Arlington Conservation Commission

DEP #091-0372: Notice of Intent: 40 Park Avenue (Continued from 11/06/25).

From: Wolfgang Kirstein <wkirstein@town.arlington.ma.us>
Sent: Friday, November 14, 2025 12:16 PM
To: Nicholas Skoly
Cc: Richard J. Vallarelli; William Copithorne; Taylor Donovan
Subject: Re: [External] Re: Arlington Stormwater Management Permit Application

40 Park Avenue

C-1

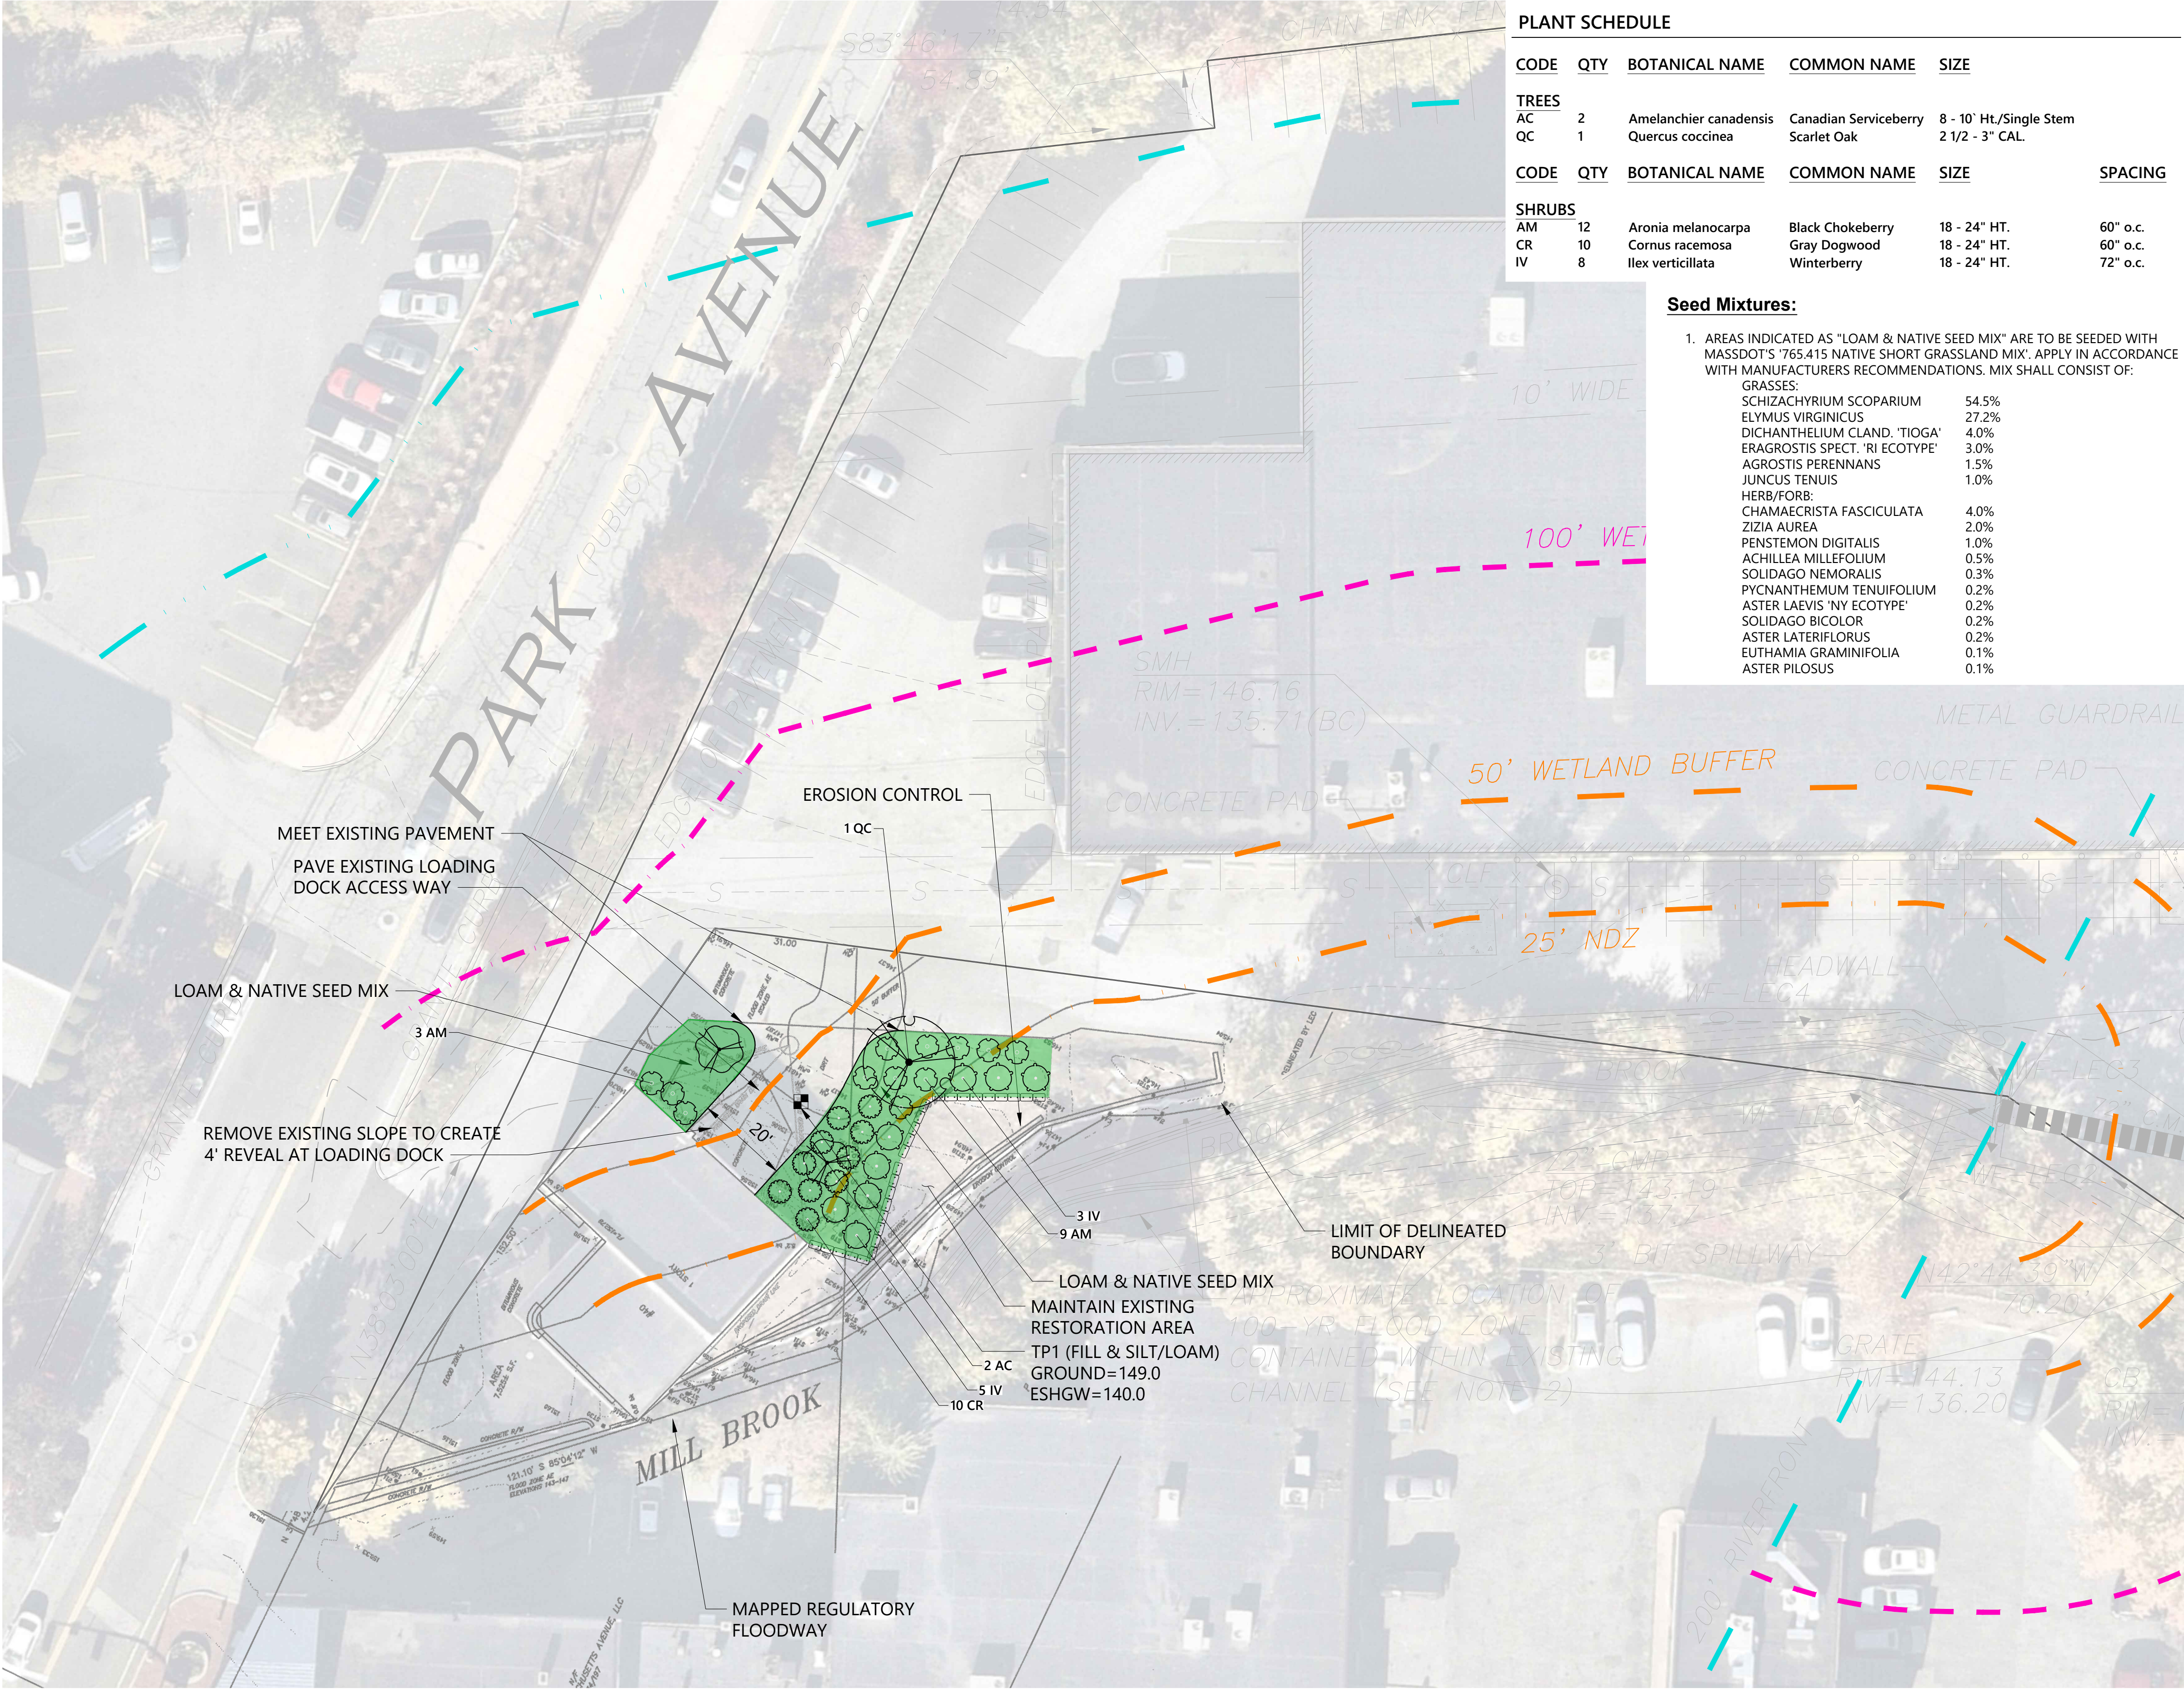
The Engineering Division find's these plans acceptable. I do have a question on the expected timing for the work, specifically if it will take place during winter or spring when the seeds can grow and keep the added loam stable.

The site was apparently required to perform mitigation adjacent to the brook and didn't want us to include that in the stormwater analysis to avoid counting any of that mitigation area as an improvement to the existing condition in this analysis. Attached is the info with the updated numbers (minimal changes) and an overlay showing which area was removed in the existing and proposed condition as it is now outside of the limit of work. All other items remain consistent with what was submitted last week.

Wolfgang- We recently completed the test pit and discovered the soil type was different than anticipated and infiltration is not feasible. Attached are the revised plans and response to stormwater comments. With our proposed landscape areas replacing the existing disturbed areas, we are actually reducing the peak rates and volumes compared to the existing conditions. Please review and let us know if you have any questions.
